UNITED STATES ENVIRONMENTAL PROTECTION AGENCY

)	
Standards of Performance for)	Docket No. EPA-HQ-OAR-2013-0495
Greenhouse Gas Emissions from)	
New Stationary Sources: Electric)	<i>Via email</i>
Utility Generating Units)	<i>May 9, 2014</i>
)

Fig. 10: Annual Capacity Factors of Existing Coal-Fired EGUs

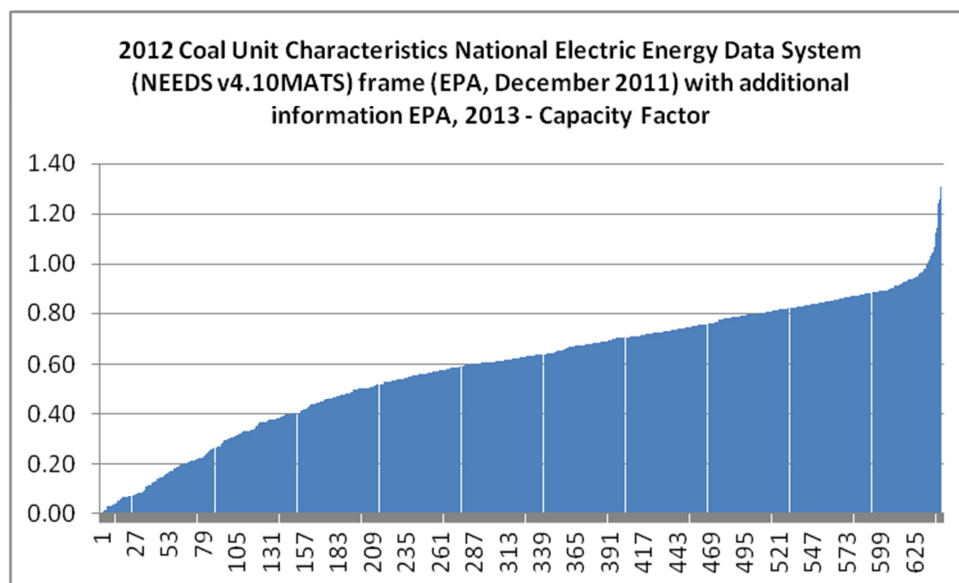
An even greater percentage of CCGTs would also be exempt from regulation under this proposal. The average capacity factor for CCGTs in 2003 was only 33.4 percent, rising over time to 42 percent in 2009. During the same time period, the average capacity factor for coal-fired units ranged from 60 to 70 percent.¹⁸⁶ Indeed, many of the “new” CCGT units evaluated by EPA in the course of reviewing its proposed limits would be exempt under the current proposal. EPA reports that the average capacity factor for the “new” CCGTs studied by the agency in the TSD for the proposed Subpart KKKK standard was 36 percent; the average capacity factor for “small” units in this study was 27 percent.¹⁸⁷ By way of illustration, we note that EPA’s review included TVA Barry Units 7A and 7B that are large (346 and 312 MW) CCGTs. These units operate year round in a load following mode, but have capacity factors in the range of 20 percent.¹⁸⁸ Having commenced operation in 2001, they reported average emission rates during the EPA study period of 801 and 878 lb CO₂/MWh, respectively. There is no reason why similarly operated new units should be exempt from the NSPS and why the Barry Units and similar units should not fall within the scope of EPA’s forthcoming emission guidelines under section 111(d). As the Barry Units reflect, the agency’s exemption under the current proposal is far too broad and could allow an unnecessarily large portion of the electric sector to avoid NSPS regulations.

Fig. 11: CO₂ Emission Rate (lb/MWh) vs. Net Plant Output- Small CCGTs

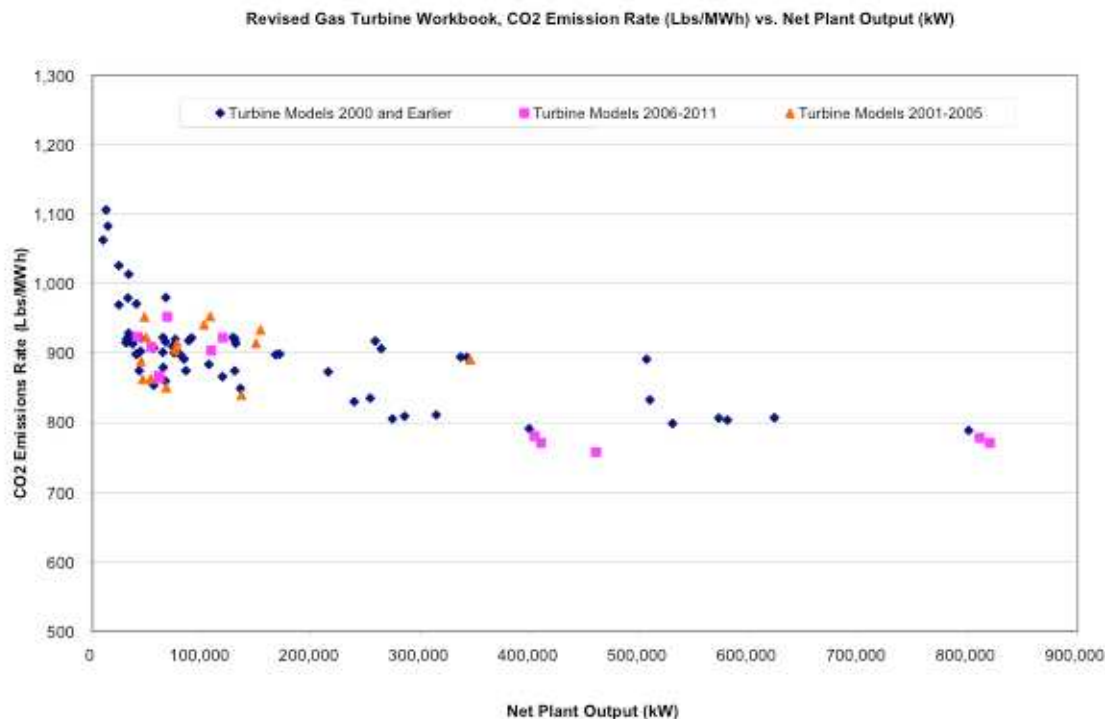
The Gas Turbine World unit performance specifications depicted in Figure 11 below show a substantial number of potential small combined cycle designs where the demonstrated emission rate at ISO conditions is at or below 900 lb CO₂/MWh.²⁰⁰ With the application of reasonable factors to account for operation at non-ISO conditions, an emission limitation of 1000 lbs CO₂/MWh (net) appears to be attainable by these units. If EPA determines that different subcategories according to size are warranted, it should clarify that multiple small units built together should be treated as a large unit if the combined output of the facility exceeds 850 MMBtu/h. We note that several recently permitted facilities included a series of 100 MW units built together.²⁰¹ Facilities should not be permitted to meet less stringent emission limits merely by building a series of smaller units rather than a single larger unit.

Taken together with our recommendation to establish three tiers of emission limits for large units based on operating hours, the “small unit” subcategory would entail a fourth type of BSER applicable to natural gas units. These four subcategories appropriately distinguish between the different types and functions of varying turbine designs while ensuring that each category achieves the optimal degree of emissions reductions.

Fig. 12: Heat Rates for Commercially Available CCGT Units in 2011

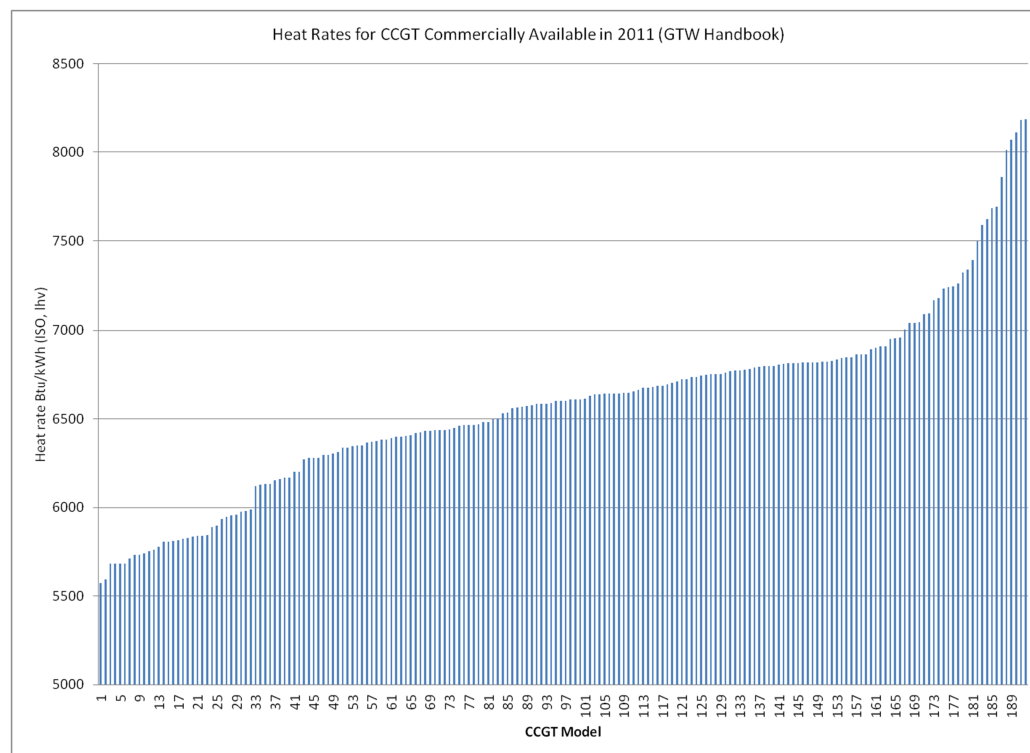
Here, by contrast, EPA has adopted a standard for new gas plants that reflects the performance of the worst performing designs available in the current fleet of CCGT plants. The data EPA relies on reveal that the performance of *existing* CCGT units varies widely in terms of efficiency. Figure 12 below depicts the heat rate for all commercially available CCGT units in 2011. At a minimum, BSER must reflect the level of performance of the best-performing existing designs from this data set, not the worst.

Moreover, the differences in efficiencies documented in Figure 12 are the consequence of deliberate decisions by designers to incorporate features and systems that enhance combustion and permit a greater amount of electricity generation per unit of fuel. In other words, there are not inherent limitations in technology that prevent better performance. For example, the performance of a CCGT unit improves when the manufacturer designs the turbine to operate at higher temperatures. For every 30 degree Celsius rise in gas turbine firing temperature, the combined cycle efficiency increases by about one percent; an efficiency of 60 percent can be reached if the design operating temperature approaches 1500 degrees Celsius.²³⁴ Improved gas turbine efficiencies can also be achieved through the use of improved thermal coatings, closed circuit steam or water cooling of turbine blades, and the use of nitrogen instead of steam as the diluent for reducing NO formation. The efficiency of a CCGT unit can be also substantially increased by using fully-fired HRSG units, which have higher (but not unreasonable) construction costs compared to partially fired or unfired HRSGs.²³⁵ These

Figure 13: Nominal Heat Rates for Units in EPA’s Study Group

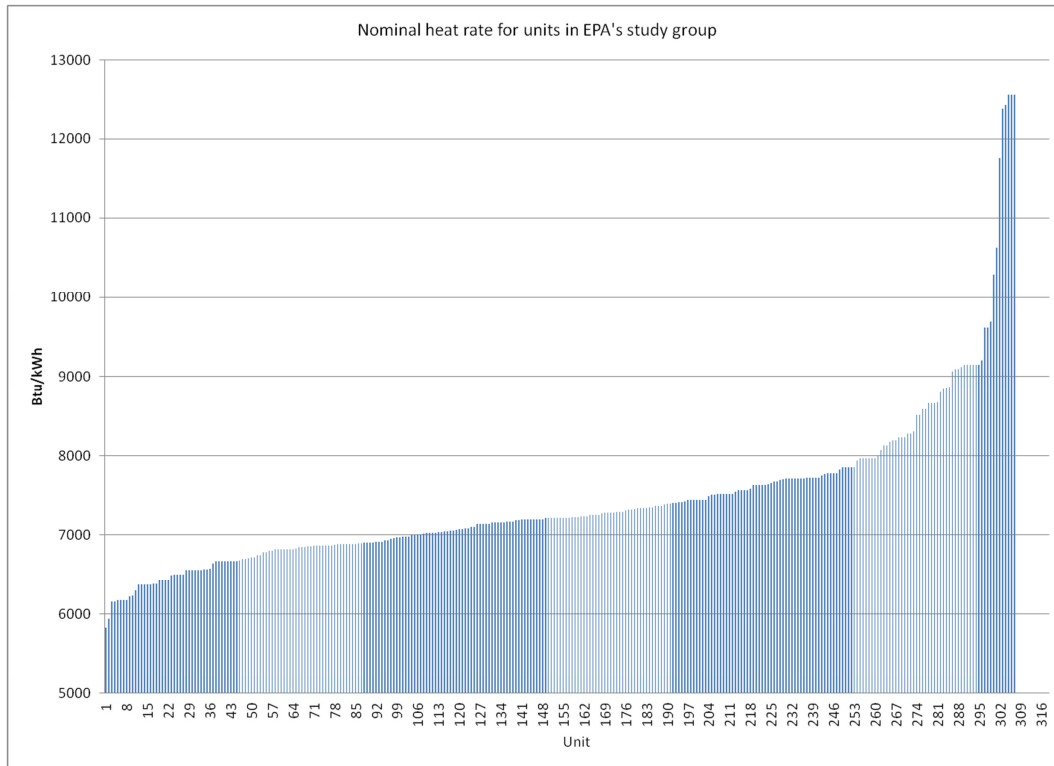
Moreover, EPA’s study excluded both units that are currently over 14 years old and new units with less than two years of operating time. As a consequence, the study did not consider 32 units whose nominal heat rate (i.e., the plant’s maximum heat input divided by rated generating capacity) is less than 7,000 Btu/kWh.

Fig. 20: Emission Rates by Hours of Operation – CCGT Plants

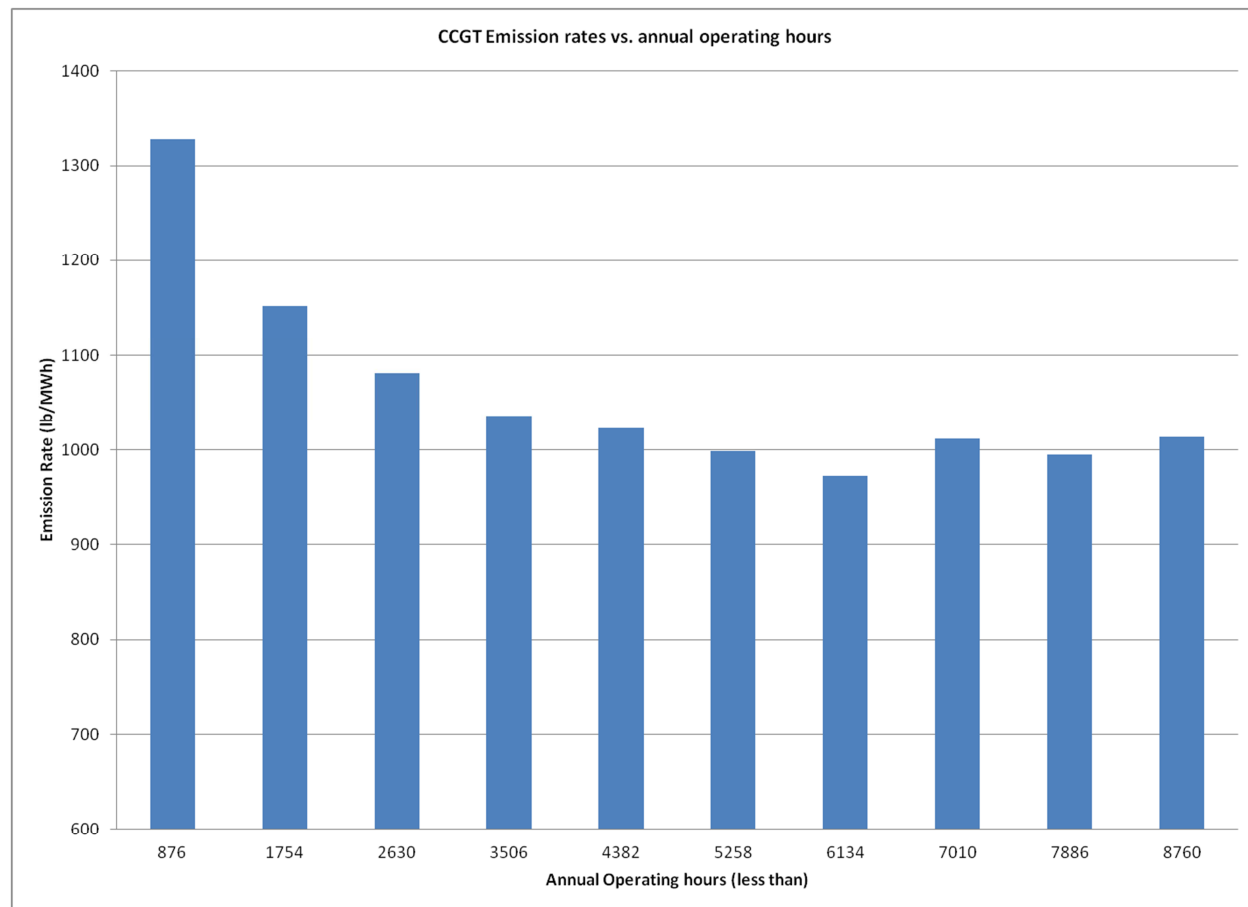
Figure 20 shows a significant decrease in emissions as units operate more hours over the course of a year.

Figure 20 shows that existing CCGT units operating at or below 876 hours annually have much higher CO₂ emission rates compared to other CCGT units. Emission rates improve as the units operate more frequently until they reach about 4400 hours annually, where they begin to level out.
